UNITED STATES
DEPARTMENT OF THE INTERIOR
BUREAU OF LAND MANAGEMENTFORM APPROVED
OMB NO. 1004-0137
Expires: January 31, 2018**SUNDRY NOTICES AND REPORTS ON WELLS**
*Do not use this form for proposals to drill or to re-enter an abandoned well. Use form 3160-3 (APD) for such proposals.***SUBMIT IN TRIPLICATE - Other instructions on page 2**

This sundry is to clarify the original COA's regarding pressure control equipment. The 5M BOP will be utilized on these wells after the surface shoe and throughout the entirety of the wellbore thereafter. The TVD for these wells are no deeper than 10,700' with pore pressures of 9.5 ppg. Therefore the MASP will NOT exceed 5M psi.

Revisions to Operator-Submitted EC Data for Sundry Notice #483348

**PECOS DISTRICT
DRILLING CONDITIONS OF APPROVAL**

BLOWOUT PREVENTER SCHEMATIC

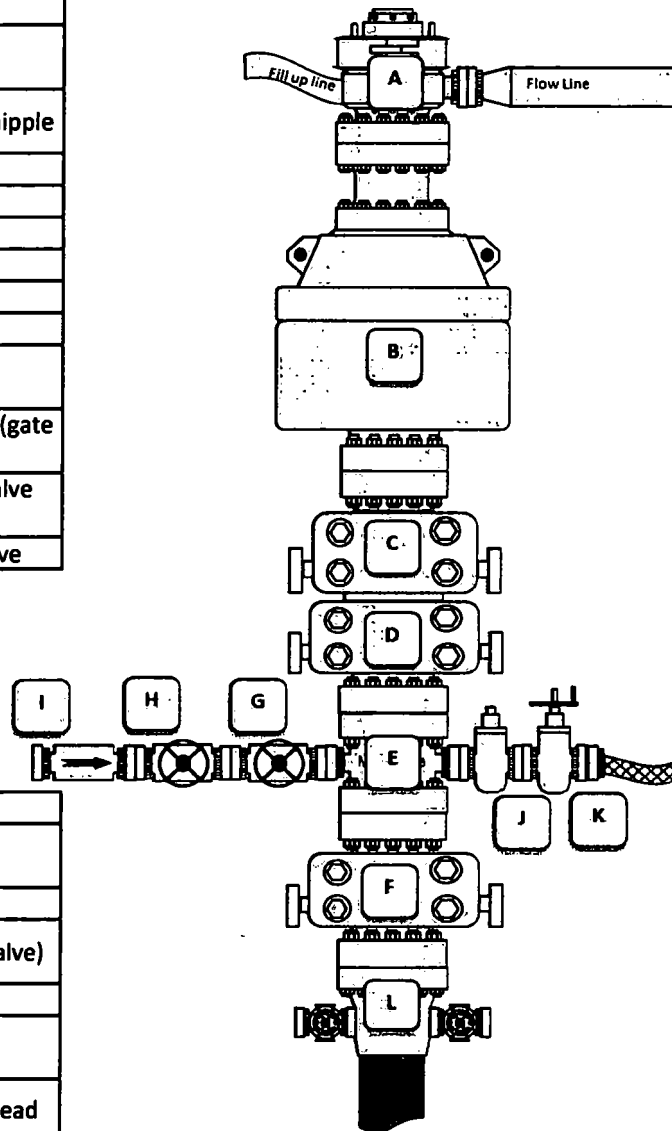
See attached BOP and choke manifold

1. Variance approved to use flex line from BOP to choke manifold. Manufacturer's specification to be readily available. No external damage to flex line. Flex line to be installed as straight as possible (no hard bends).'
- 2.

- a. Minimum working pressure of the blowout preventer (BOP) and related equipment (BOPE) required for drilling below the surface casing shoe shall be **5000 (5M)** psi.
- b. Minimum working pressure of the blowout preventer (BOP) and related equipment (BOPE) required for drilling below the intermediate casing shoe shall be **10,000 (10M)** psi.
